ADVISORY
 BULLETIN

No. 99-5

Fuel Starvation

1987 and later, 30 Thru 250 HP, (with square fuel pump)

57859

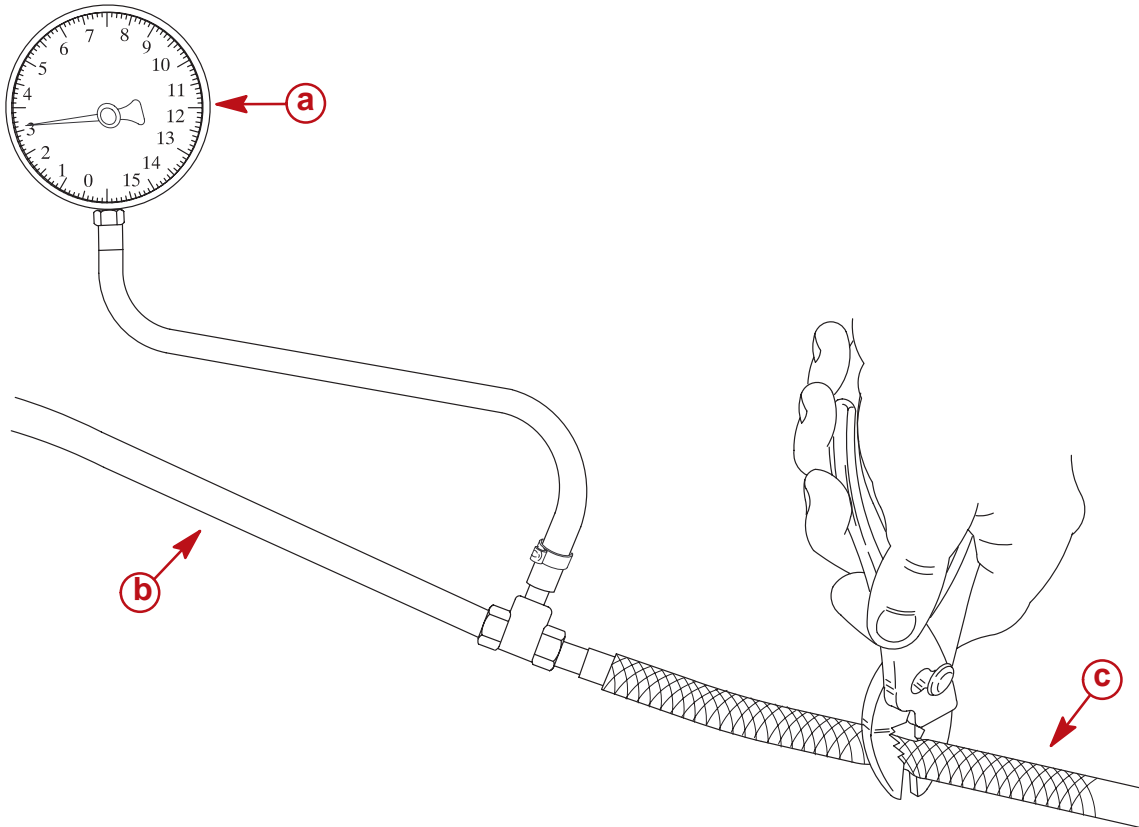
Fuel system vacuum can be checked using a short piece of extra fuel hose, vacuum gauge, and a "TEE" fitting.

- Remove pulse pump inlet hose.
- Connect extra hose to pulse pump.
- Connect "TEE" fitting to extra hose.
- Connect vacuum gauge to "TEE" fitting.
- Reconnect fuel inlet hose to "TEE" fitting.

Make the T-fitting connection as close to the fuel pump as possible.

Before proceeding with the system vacuum test confirm that the pulse fuel pump is capable of supplying the required vacuum. To do this, start the engine, pinch off/restrict the fuel supply hose between the vacuum gauge and fuel tank. The vacuum gauge should rise to or exceed the maximum normal reading of 2.5 inches vacuum (mercury). If it fails to reach this minimum number the pump needs servicing or there is a lack of crankcase pressure to operate the pump.

57861

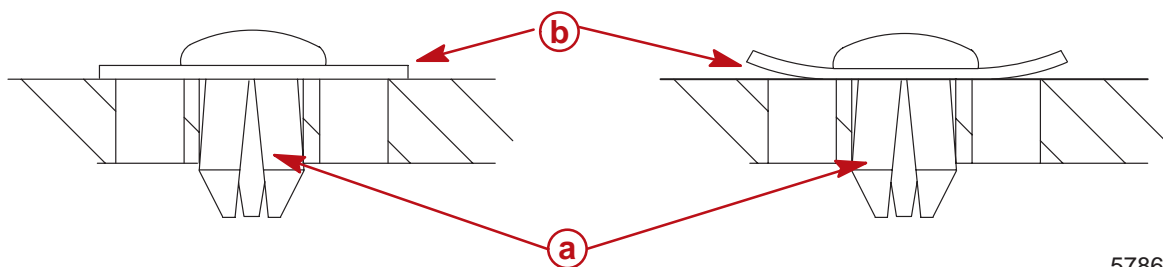
The new repair kits contain check valves made of a plastic material, impervious to damage from additives. When repairing the fuel pump discard old rubber and small plastic check valve disks, and install one new plastic disk under each retainer. Caution must be taken not to push the check valve retainer to tightly against the check valve, this may cause valve to deform.

The new plastic check valve started in production at the serial numbers listed below.
